WM Project Number: 19517
Our Ref: AM 190520 bc.docx
Email: adam@landmarkgr.com

Re: 2 Delmar Parade Dee Why - Apartment Orientation and Noise

Revised Layout

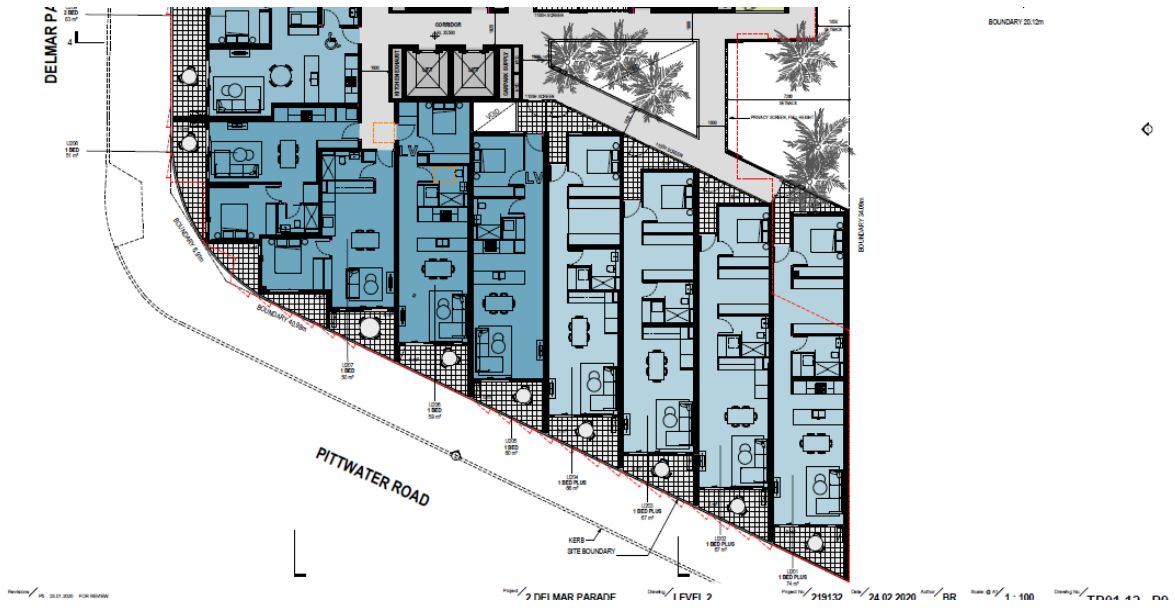
We have reviewed the re-orientation of the lower level apartments so that they are not perpendicular to Pittwater Rd with respect to acoustic amenity. The adoption of this apartment orientation will result in a beneficial reduction of noise exposure to future occupants of the apartments.

The current design utilises the orientation of the site to provide the following attributes that enhance the acoustic amenity of subject Pittwater Road apartments as follows:

- The longer living areas means that an increased reduction in traffic noise will occur in the living areas as occupants are further away from the Pittwater Road facade.
- More sensitive areas, being bedrooms, are now located away from Pittwater Road on the eastern end of apartments and are now not exposed to traffic noise at all.

In conclusion the revised apartment orientation and design adopts recommend good design sympathetic to the site layout that will result in a better acoustic outcome for future occupants of the subject apartments.
